**The Proposed Broadwater LNG Import Terminal
Update of Synapse Analysis**

Prepared by:
Ezra Hausman and Kenji Takahashi,
Synapse Energy Economics
22 Pearl Street, Cambridge, MA 02139
www.synapse-energy.com
617-661-3248

January 19, 2007

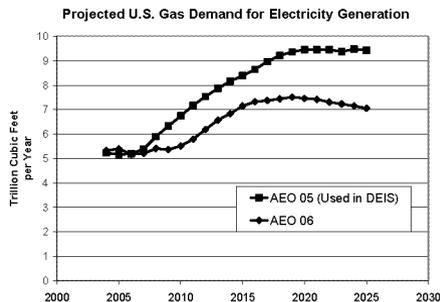
None of these recent events has altered our basic conclusion, that the Broadwater terminal is not required to meet the future energy needs of New York and Connecticut. To the contrary, both of our most basic conclusions have been strengthened. The newer forecasts for gas demand over the next two decades have been revised significantly downward relative to previously available forecasts, largely due to the disappearance of additional gas-fired electricity generation from utility resource plans. This change in projected gas demand for electricity generation is shown in the figure below.
